The Cutaway — Architectural Design Response
iNSW — Rev G — 31/08/23

Project Name	The Cutaway		
Project Code	BCY		
Revision	Date	Comment	Approved
0	31/05/23	Draft Issue	EC
A	06/06/23	Issue for Review	EC
B	07/06/23	Final Issue	EC
C	14/06/23	Final Issue	EC
D	26/06/23	Final Issue	EC
E	21/07/23	Reissue for DPE	EC
F	27/07/23	Reissue for DPE	EC
G	31/08/23	Reissue for DPE	EC
H	08/09/23	Reissue for DPE	EC

Ground floor - northern amenities plan

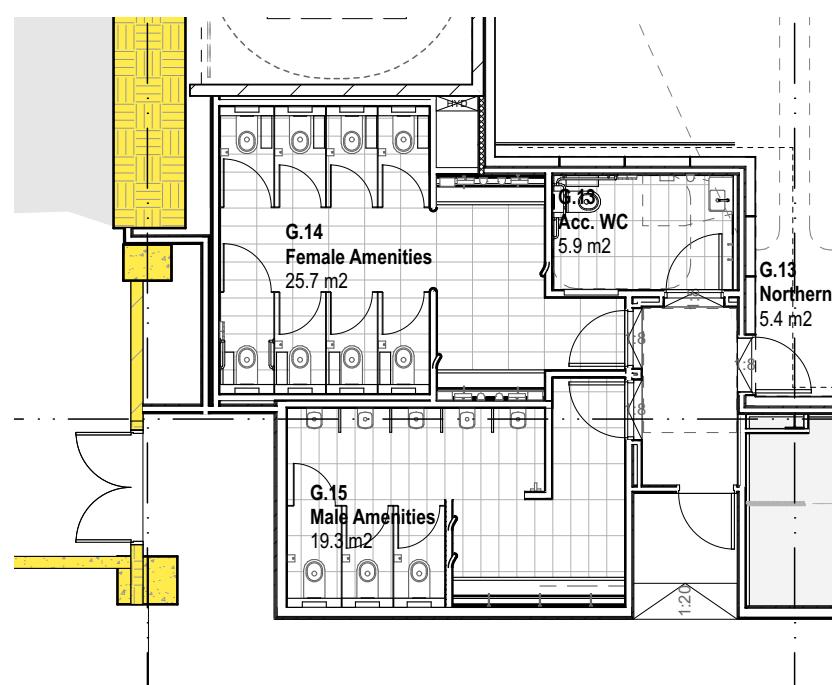
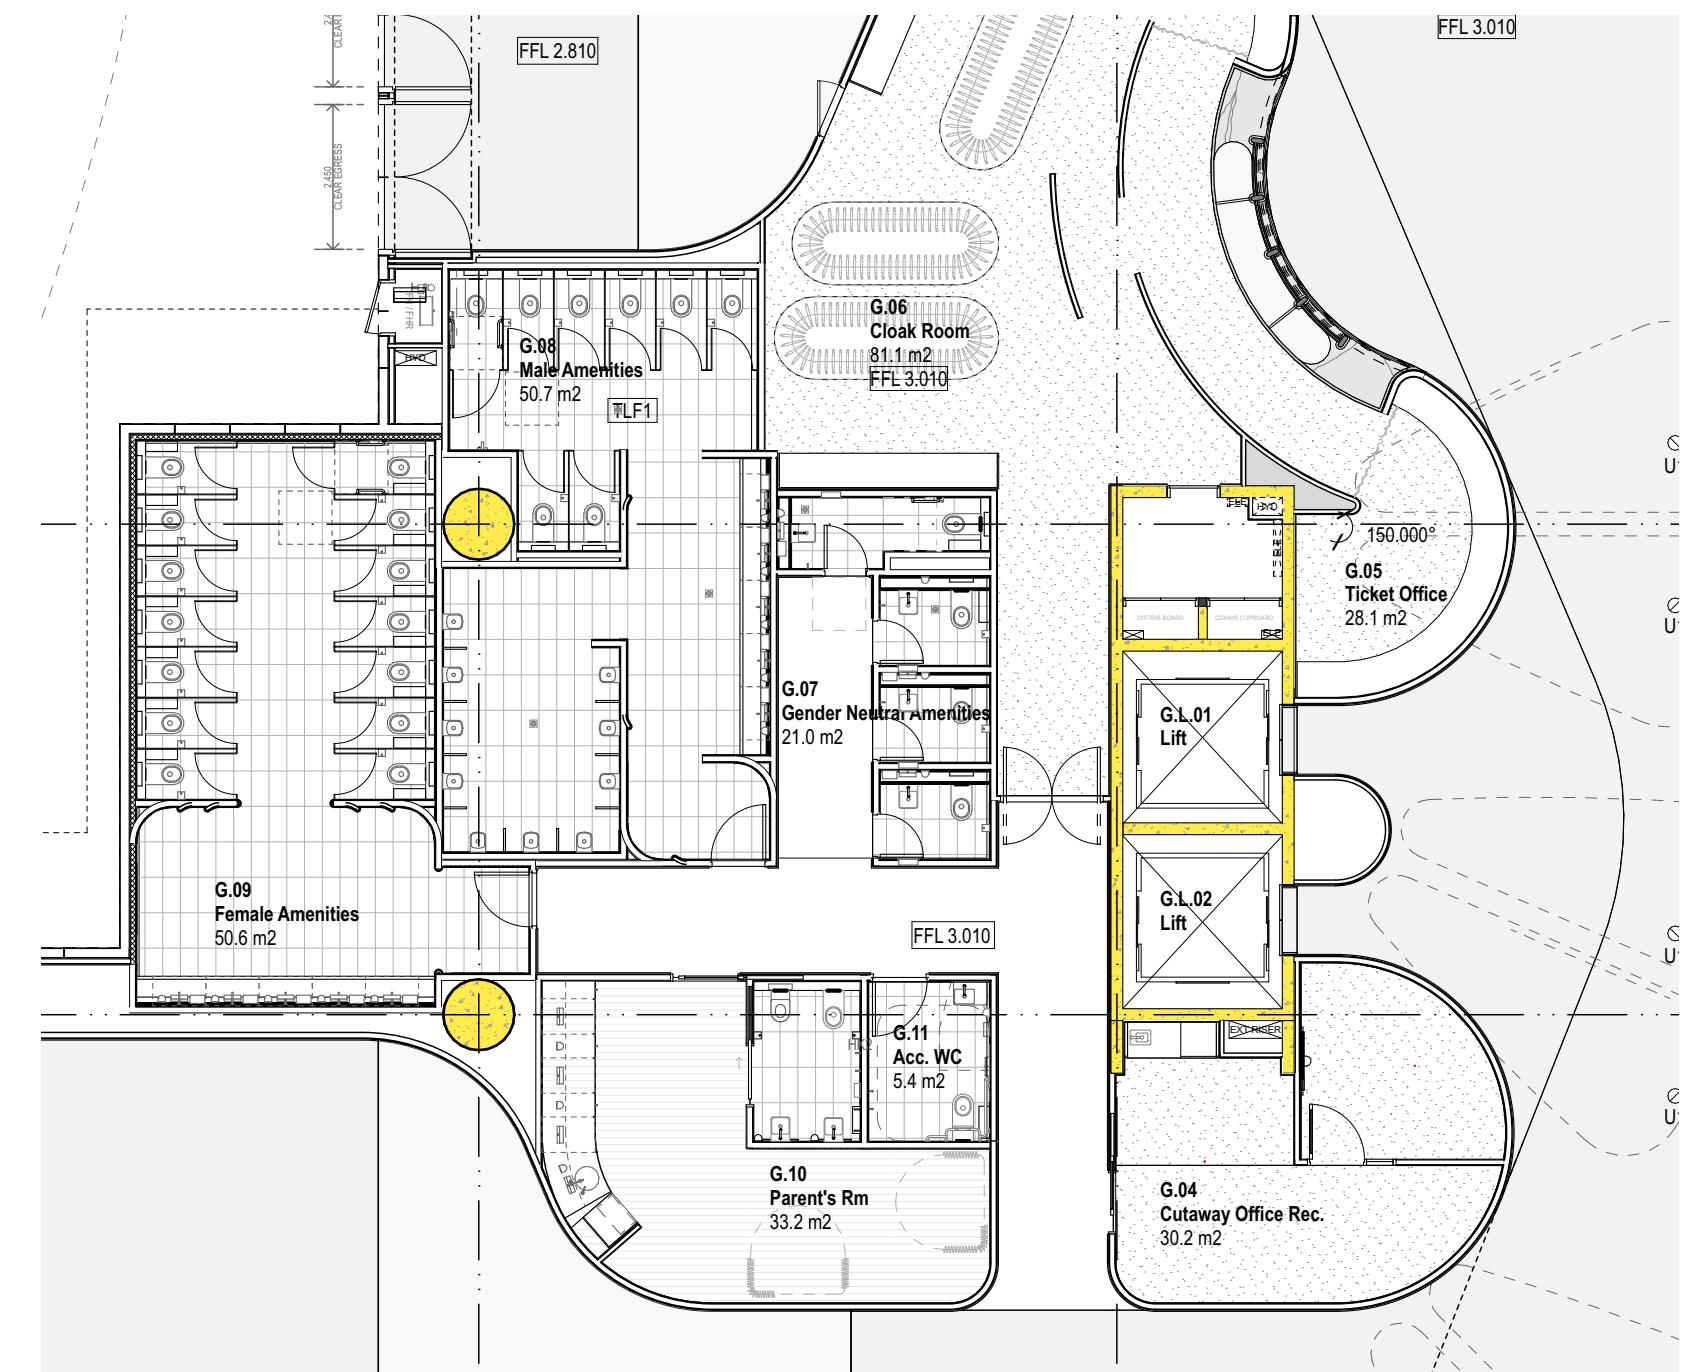
Provision of public amenities in accordance with BCA standards is to be reviewed to ensure appropriate facilities are provided, including Accessible Adult Change Facilities and ambulant toilet have compliant clearances.

Consider how access to public amenities is retained in different event layout configurations. Some test layouts contained in Appendix 3 – SSDA Architectural Design Report block amenity access, such as catwalk seating (p.51) and theatre seating bank and flat floor seating (p.52).

We have provided public amenities in excess of the BCA requirements for servicing the Event Hall — please refer to the latest plans shown below.

We have designed a space which is open and flexible, and can address multiple event configurations. As such, temporary event layouts can be adjusted to suit the base conditions.

Locating amenities at either ends of the space allows for flexibility in access during different event modes.
